MATERIALS LICENSE

Amendment No. 45

September 25, 1996

re: US NRC Region III letter from CFGill to CWSmith
dated August 28, 1996 and NRC Control # 301423.

Appendix 3

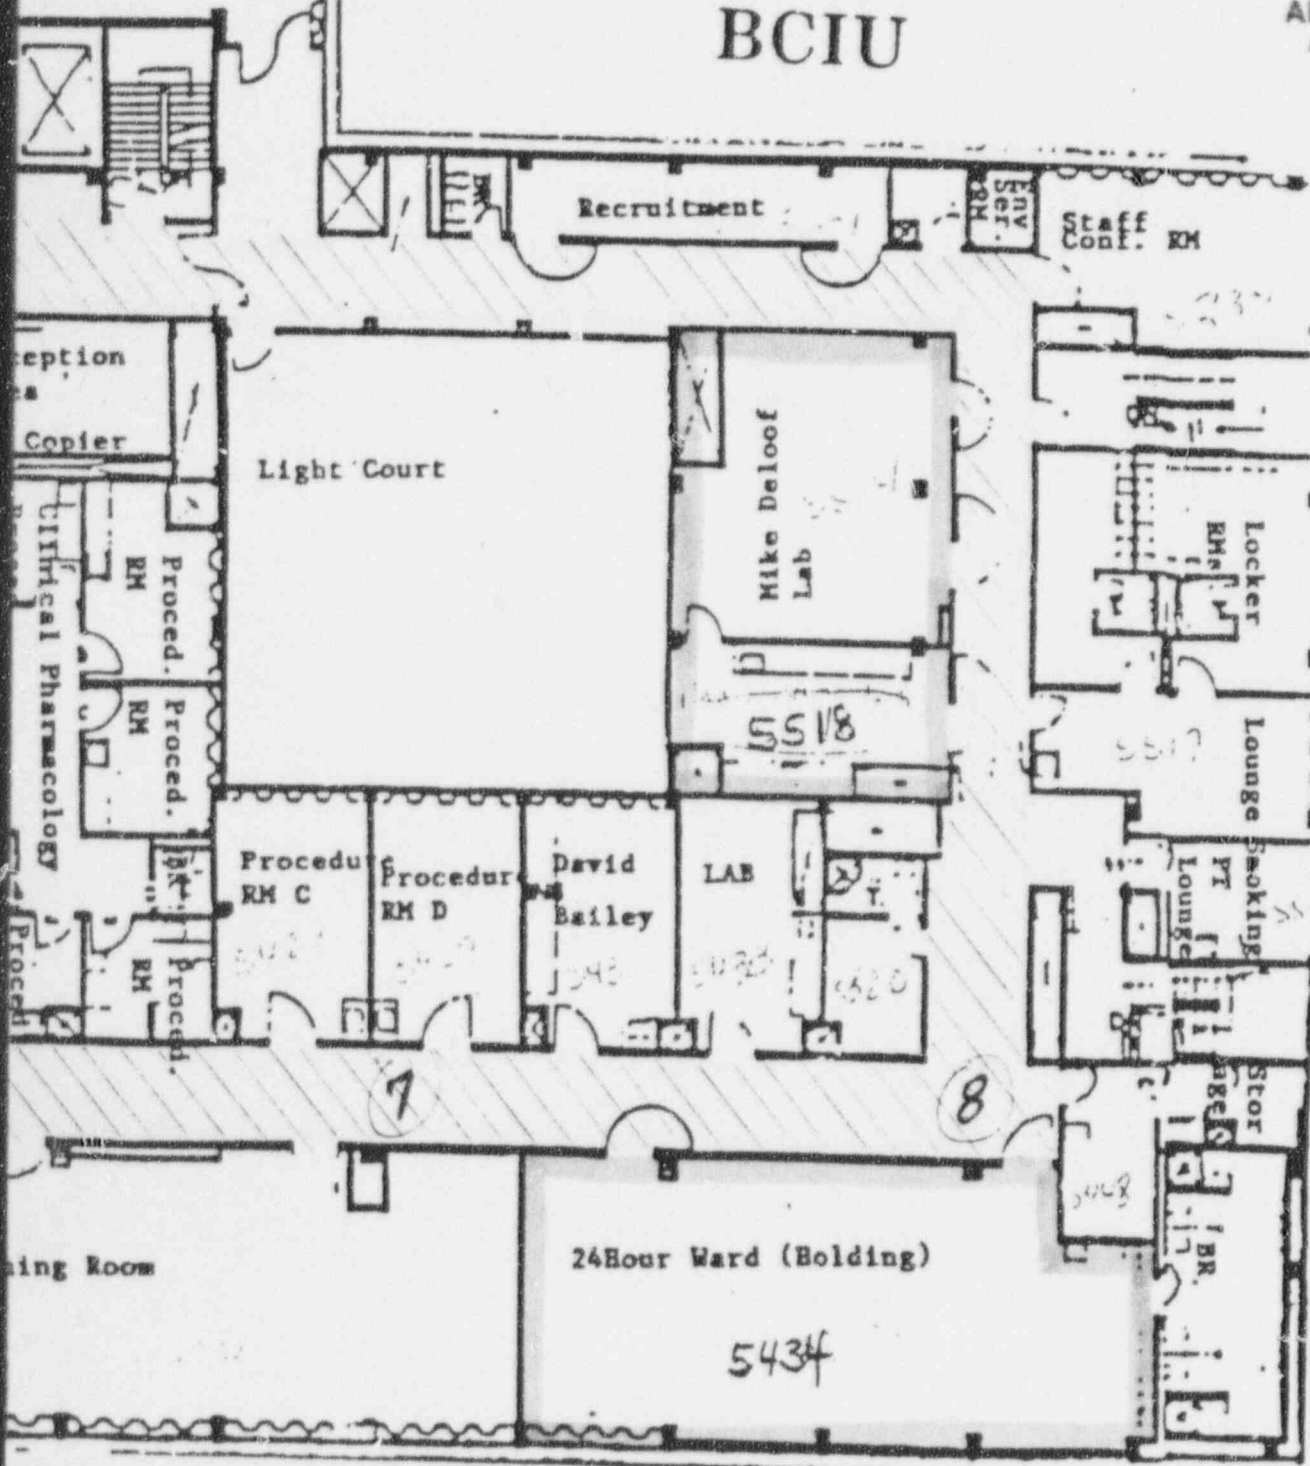
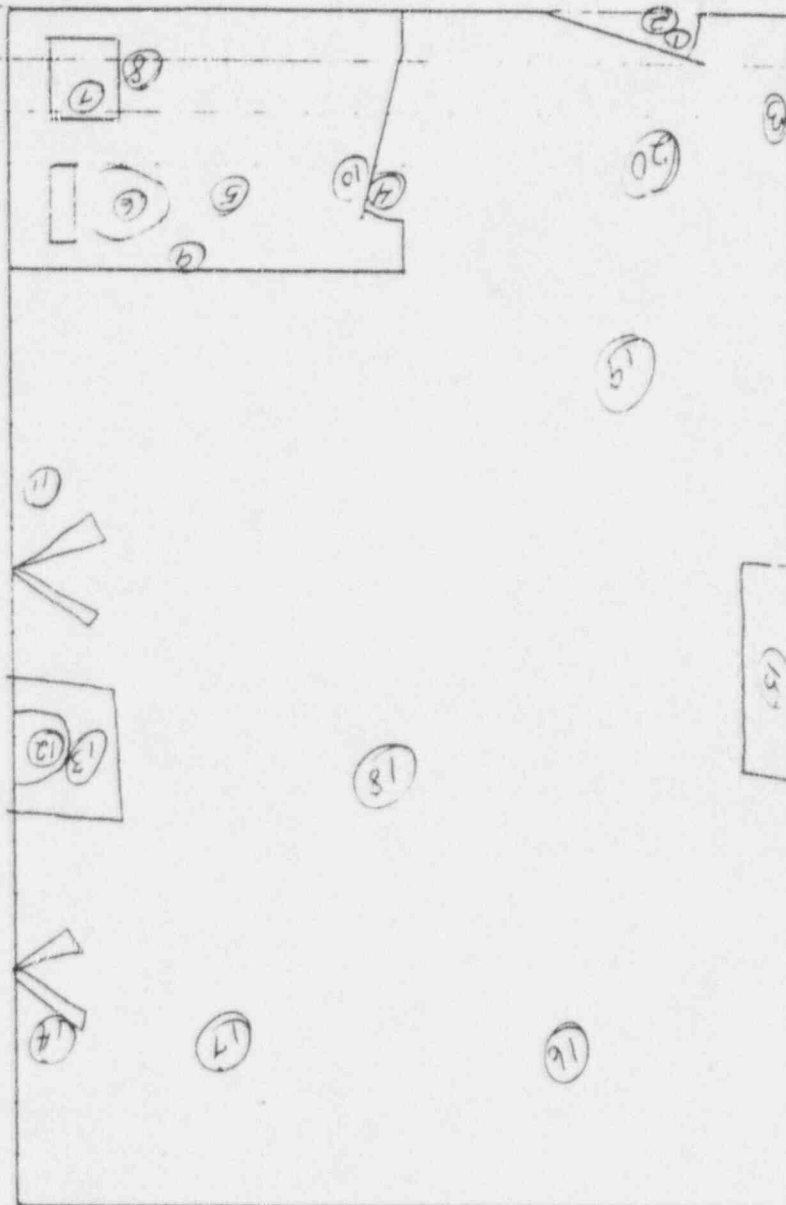
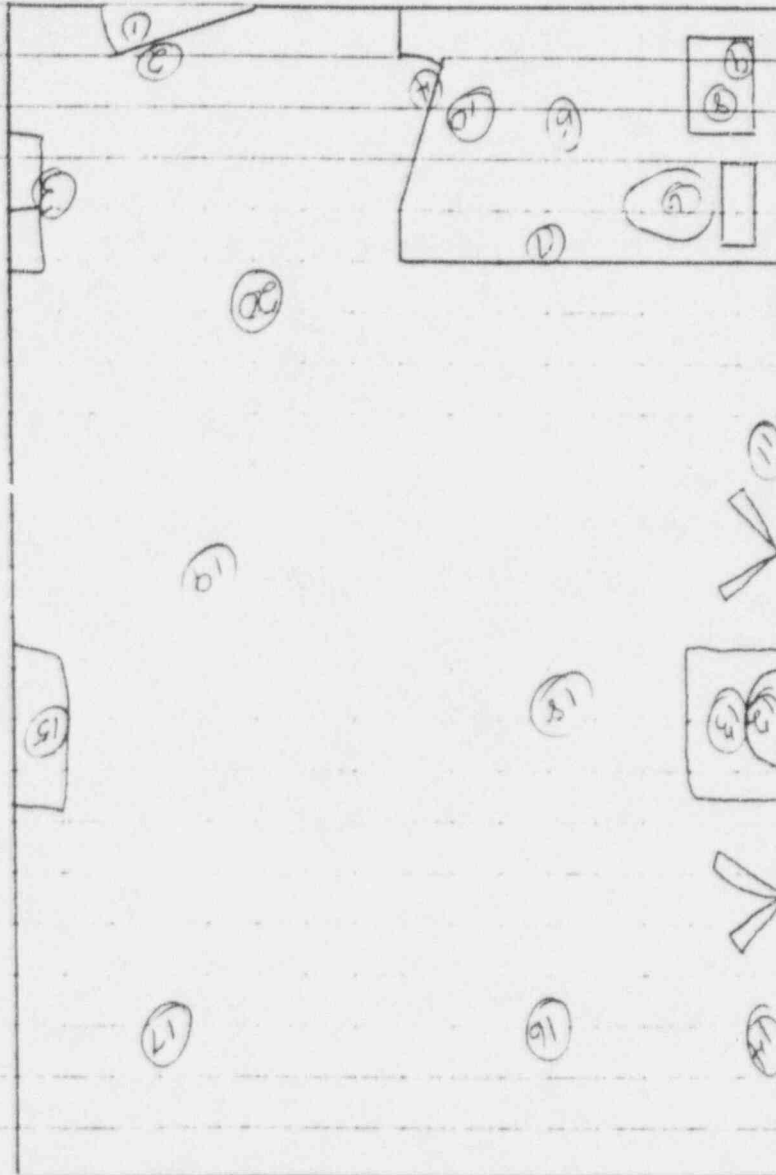
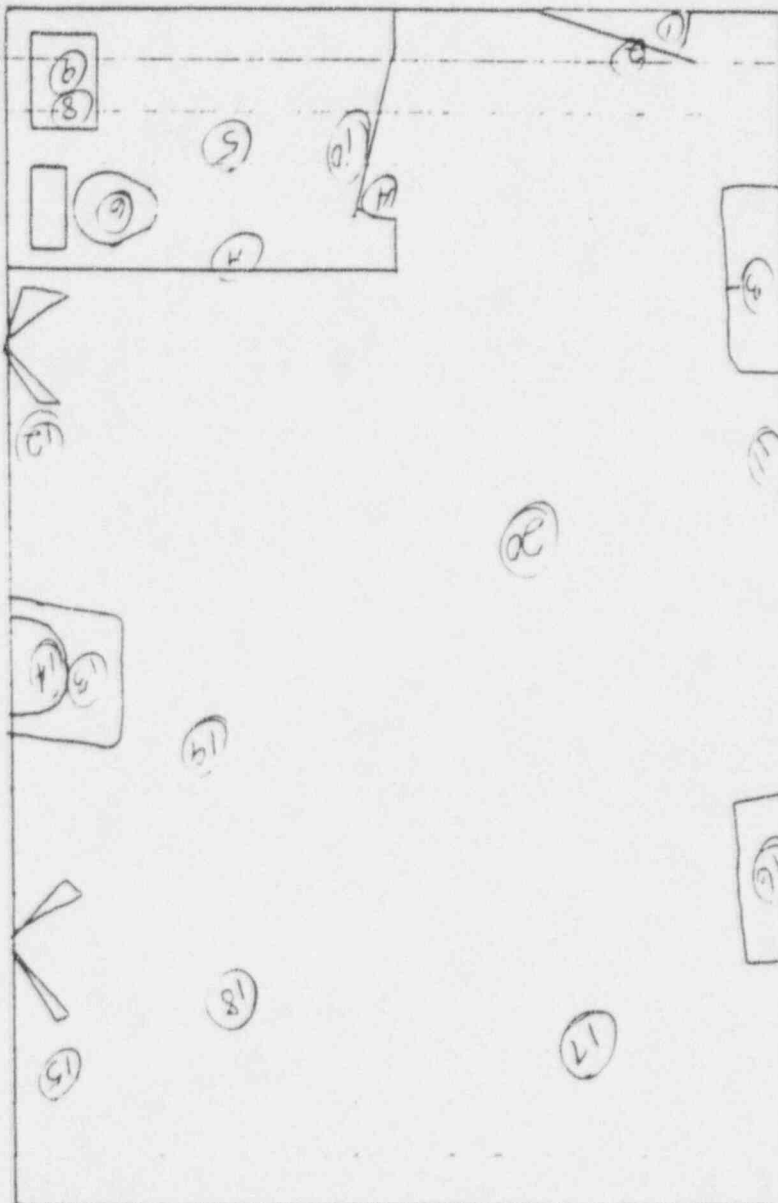
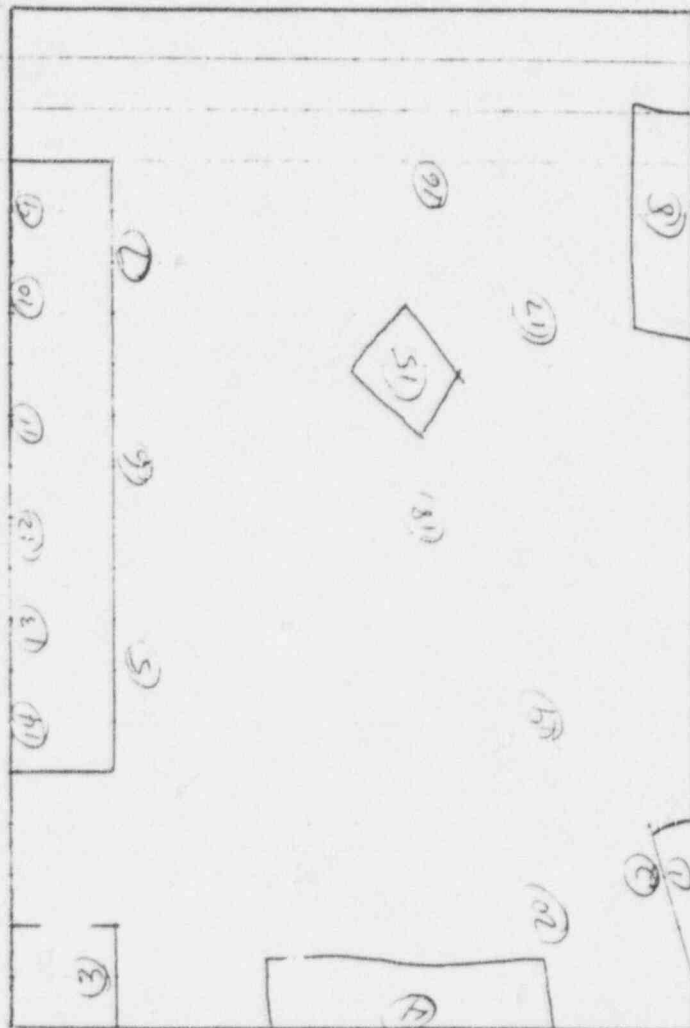
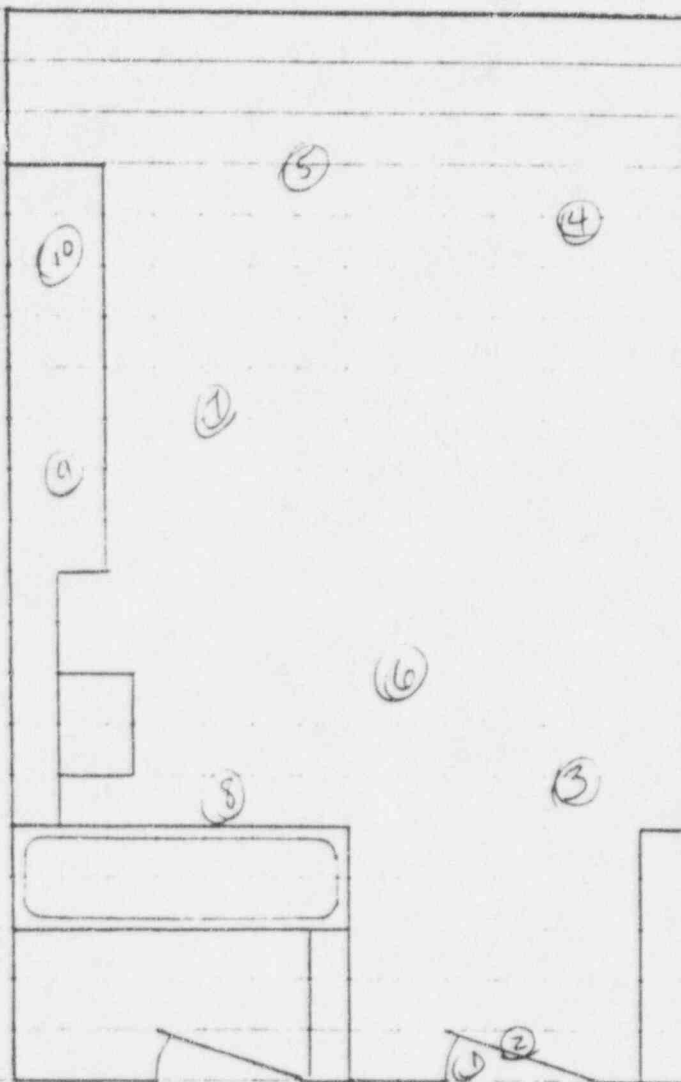
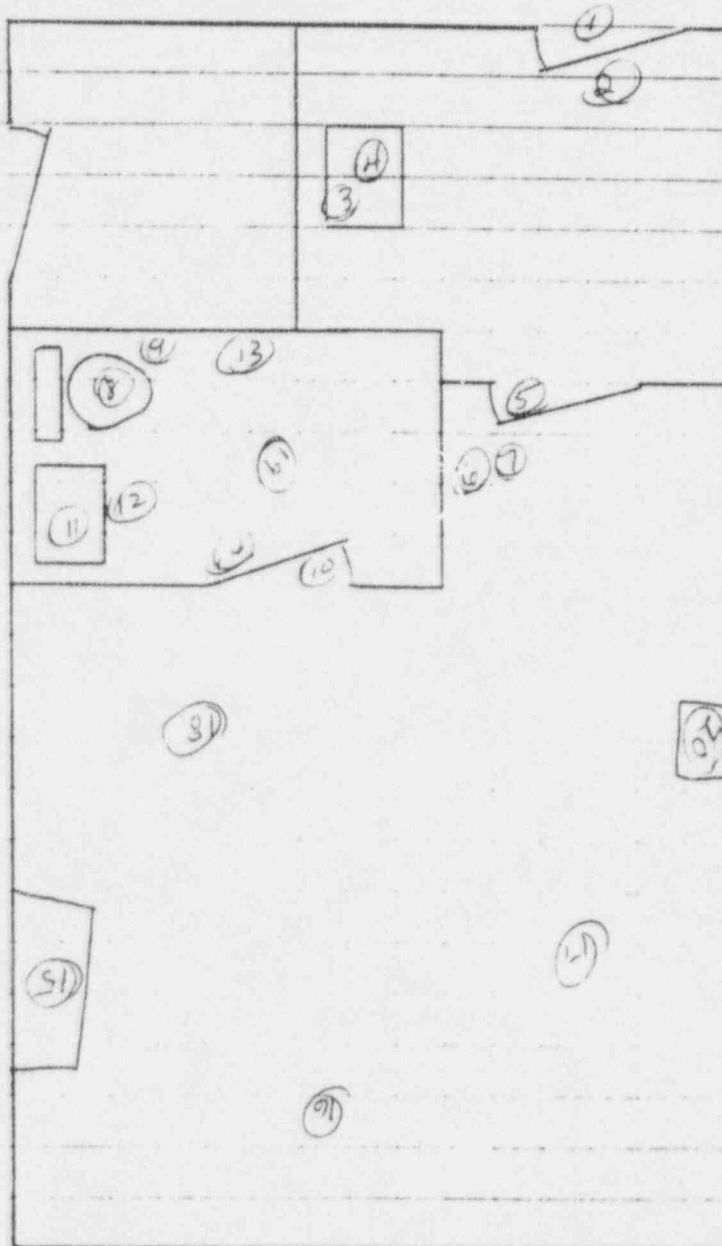
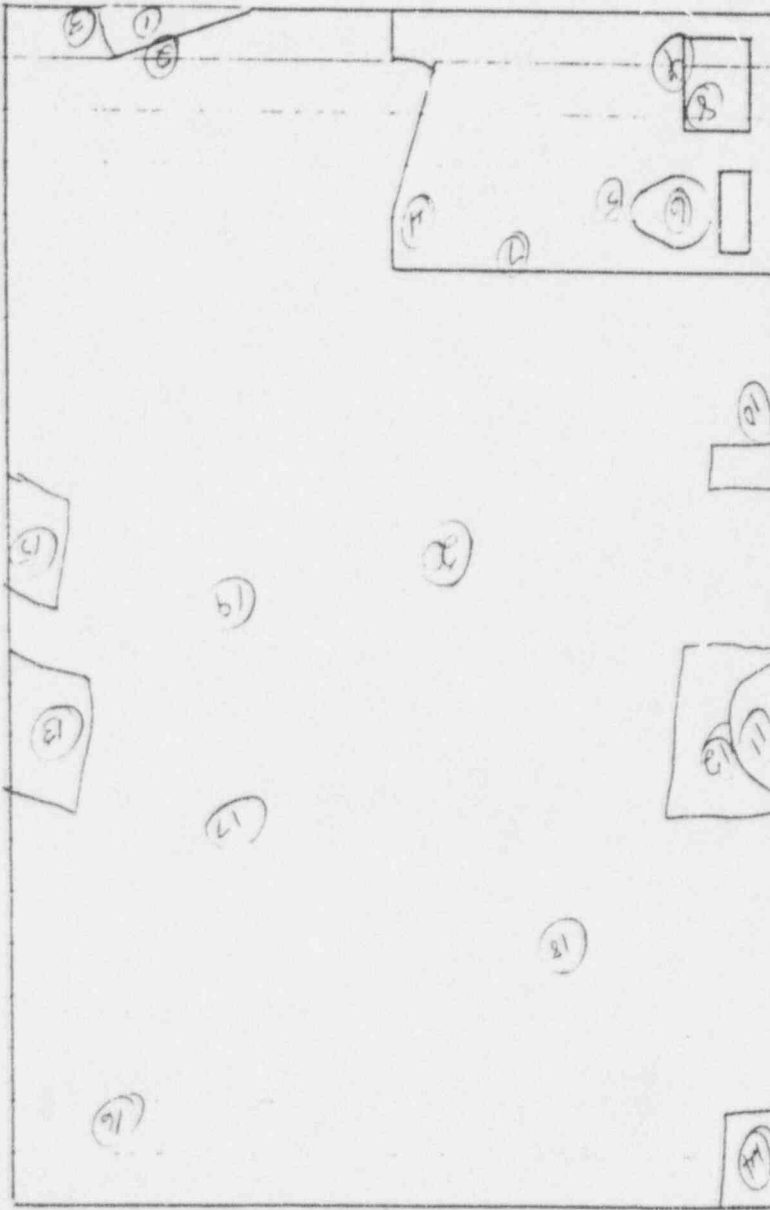
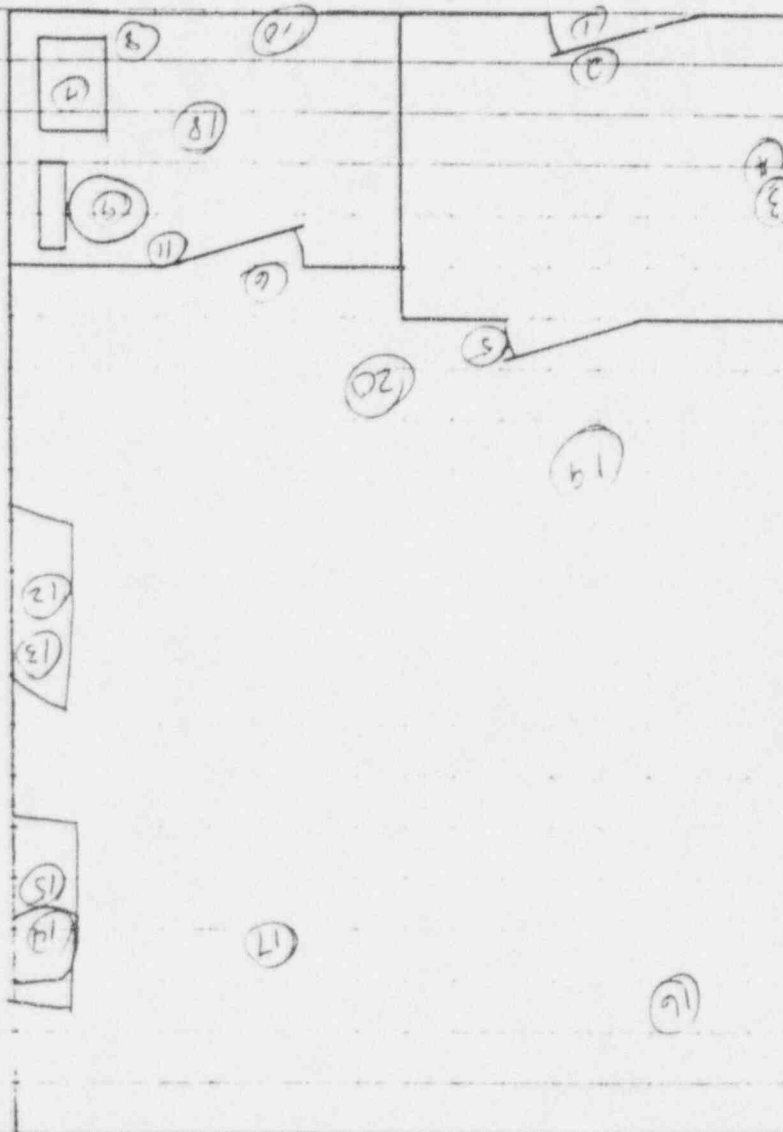
Please submit... a diagram of your old facility with survey and wipe test results keyed to specific locations. Please record your survey results using the appropriate units as described in 10CFR30.36(j)(2)(i). (Records should include) the name of the person performing the survey, the date the survey was performed, the instrument(s) used for exposure rate measurements and for analysis of the wipes, background readings, and the date that the survey instrument was last calibrated.

Appendix 3 provides the revised records of the wipe test results and direct surveys for areas in BCIU where radioactive material was used or stored. As far as can be determined, radioactive material was transported in the hallways and use in 13 specific rooms. Surveys for these areas are enclosed.
